Office Action Summary	Application No.	Applicant(s)	
	10/731,950	KIM ET AL.	
	Examiner	Art Unit	
	HOAN C. NGUYEN	2871

DETAILED ACTION

1. Claims 1, 6-12, 18, 22-31, 35 and 46 are rejected under 35 U.S.C. 103(a) as being unpatentable over Yamamoto et al. (US6445432B2) in view of **Midorikawa et al. (US 6281955 B1)**.

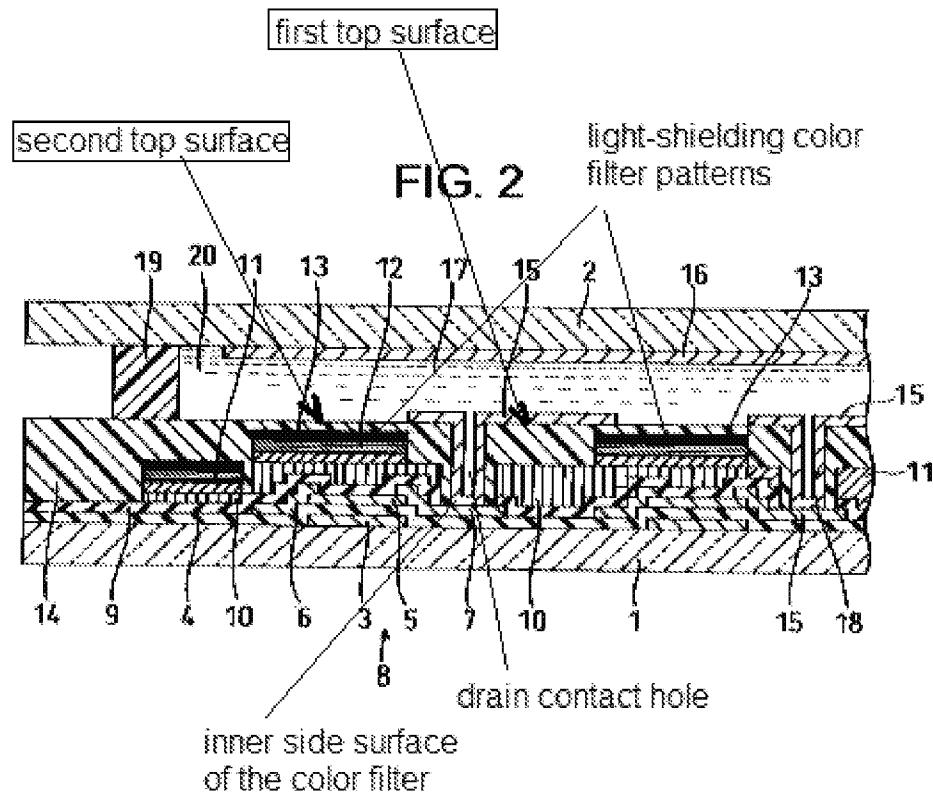
The secondary reference Midorikawa et al. (US 6281955 B1) disclose the plurality of pixel electrodes 30 formed directly on top surfaces of the plurality of color filters 24; Midorikawa et al. fail to disclose "the first and second top surfaces face the common electrode and have the

same level". However, the primary reference Yamamoto et al. (US6445432B2) discloses "the first and second top surfaces face the common electrode and have the same level".

FIG. 3

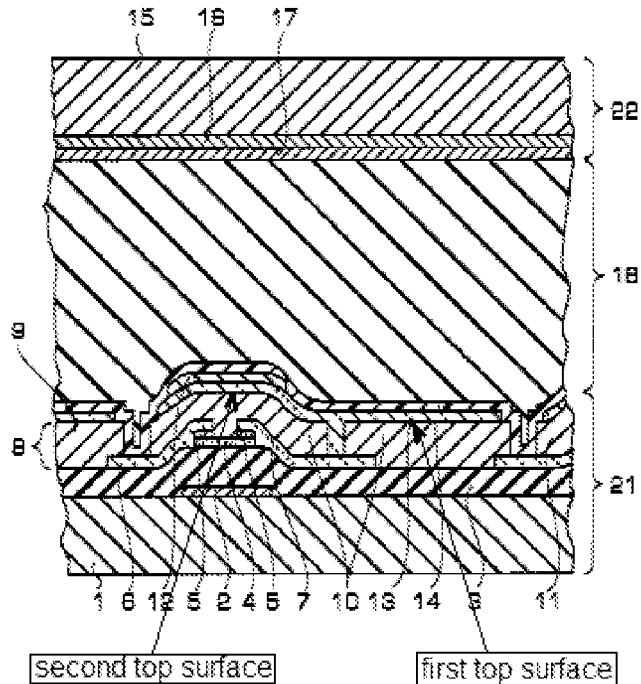
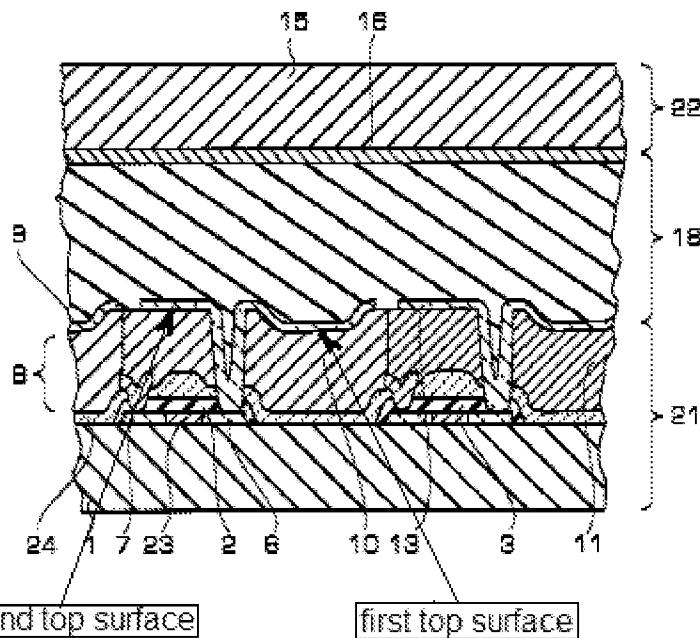
Yanai teach (Figs 3-4) the plurality of pixel electrodes 13 formed directly on top surfaces of the plurality of color filters 10 [wherein the first and second top surfaces face the common electrode and have the same level].

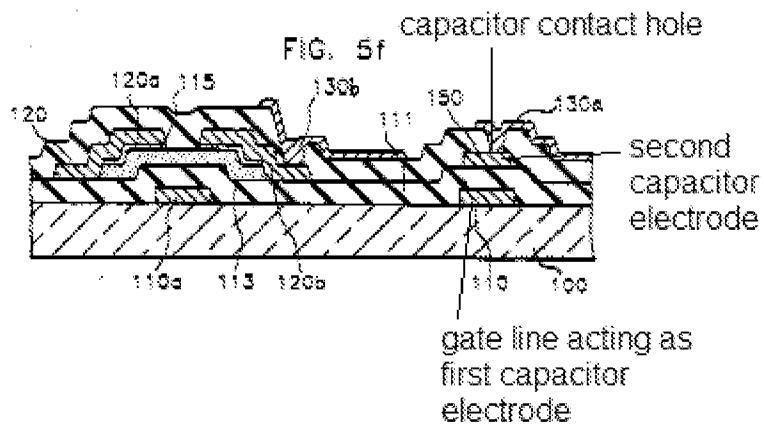
Shin teaches (Figs. 2-3) a liquid crystal display device comprising the source and drain electrodes are formed on the ohmic contact layer 5 and spaced apart from each other, and wherein each thin film transistor includes a channel on the active layer 4 between the source and drain electrodes for reducing the contact resistance between the active layer and the source/drain regions in the completed device as taught by Shin (col. 1 lines 43-48).
